REQUEST FOR INFORMATION

REFERENCE: Shields & Brawley E.S.

SUBJECT: Structural Detail Callout

SHIELDS & BRAWLEY ELEMENTARY SCHOOL

DRAWING #: S5.4, S7.8/18

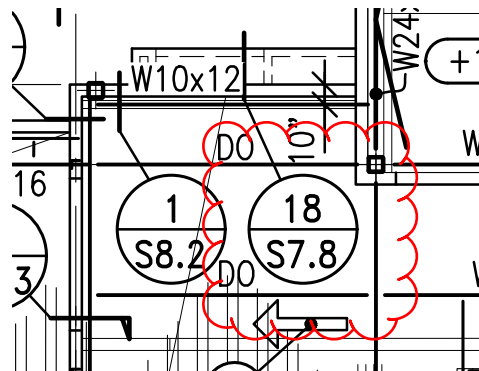
On S5.4, near gridline D between 8 and 6, detail 18 on S7.8 is called out. This detail and page cannot be located.

Please clarify or locate correct page/detail for this location.

[ASDi response:](#)
[See new detail XS-1 \(PENDING DSA APPROVAL\).](#)

DET. AT DRINKING FOUNTAIN

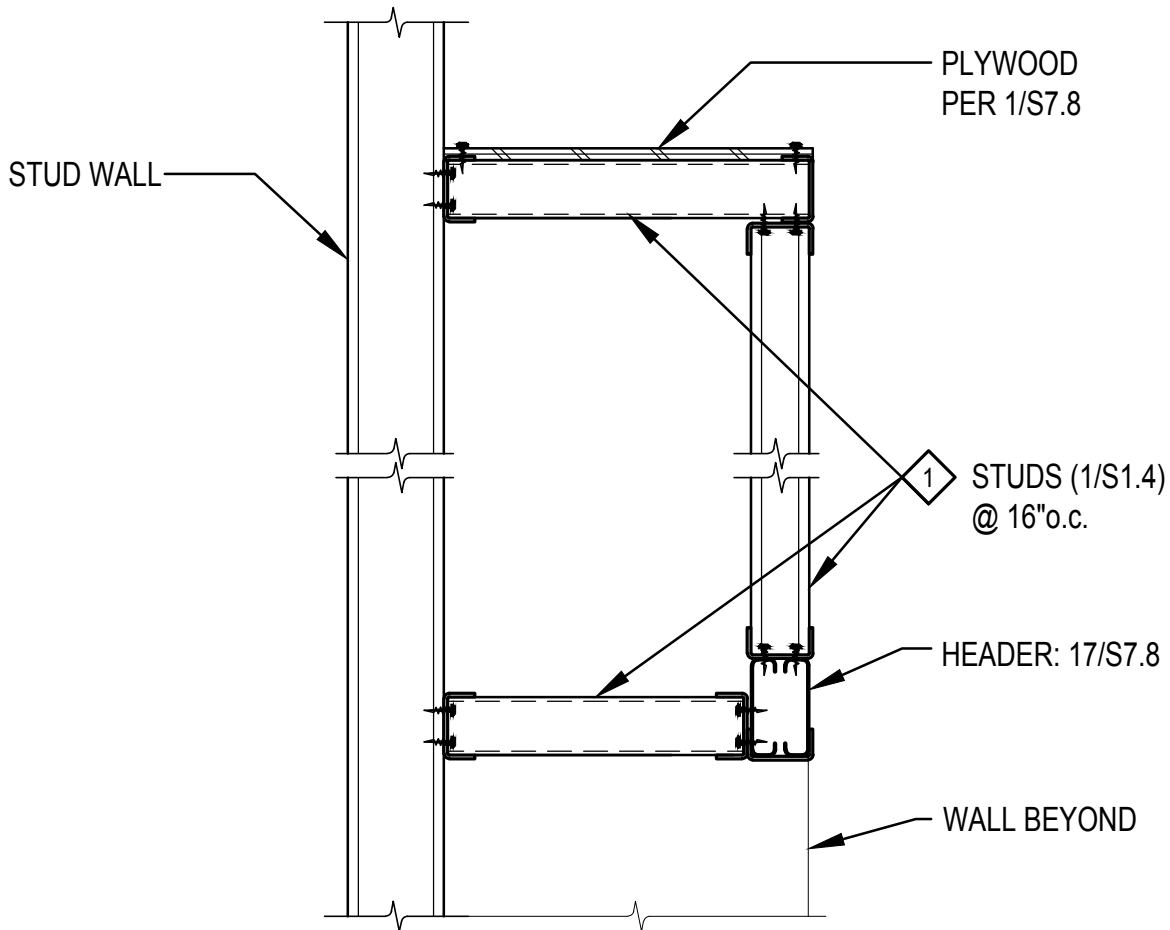
SCOPE: DETAIL AT DRINKING FOUNTAIN WAS NOT INCLUDED IN DSA APPROVED SET.
